SEA LINK CHANGE REQUEST 1
OPEN FLOOR HEARINGS 3
10am Tuesday 24 March 2026

The Five Changes: On 5 December the Examining Authority (ExA) accepted [\[PD-015\]](#) the Sea Link Applicant's (NGET) five proposed changes of Change Request 1 [\[CR1-001\]](#). The relevant documents are available in the [Examination Library](#) listed from [\[CR1-001\]](#) to [\[CR1-068\]](#).

Figure 1

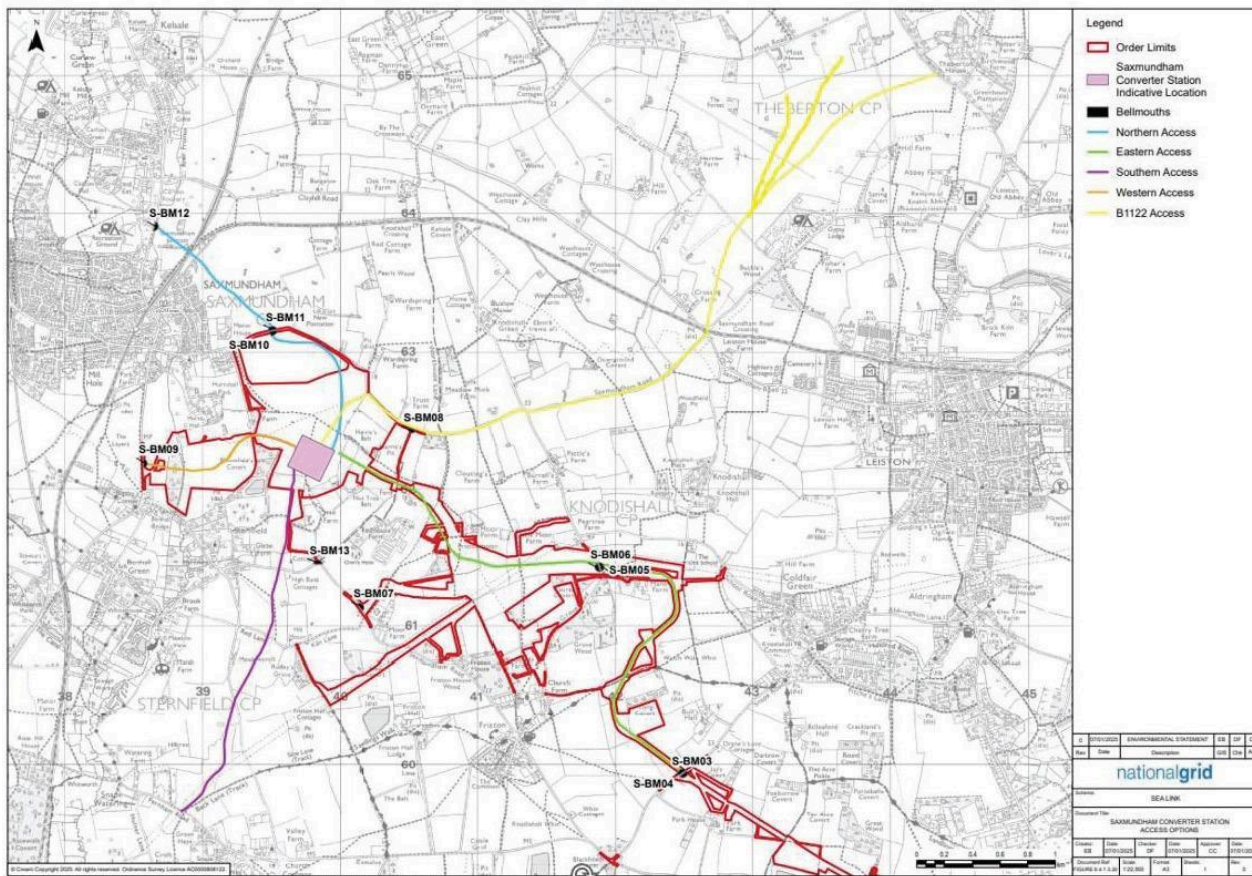
Figure 1 below illustrates the Alternative Northern Access Route put forward by Suffolk County Council (SCC) as a credible way of reaching the proposed Saxmundham Converter Station site. SCC has consistently argued that this northern option has not been adequately considered, even though it avoids the complex constraints of the Benhall Railway Bridge and removes the need for a permanent new bridge and embankments across the Fromus Valley, and reduces impacts on the sensitive landscape around Heritage sites. By making use of existing strategic corridors such as the B1122/Sizewell Link Road alignment, the northern route offers, in SCC's view, a more deliverable and lower-impact option should the Examining Authority find the currently proposed southern route undeliverable. It also reflects a wider principle that major energy developers should coordinate infrastructure planning to minimise cumulative impacts on local communities and landscapes, rather than designing access routes in isolation.

[SEAS](#) supports [Suffolk County Council's](#) objection to the Benhall Railway Bridge access.
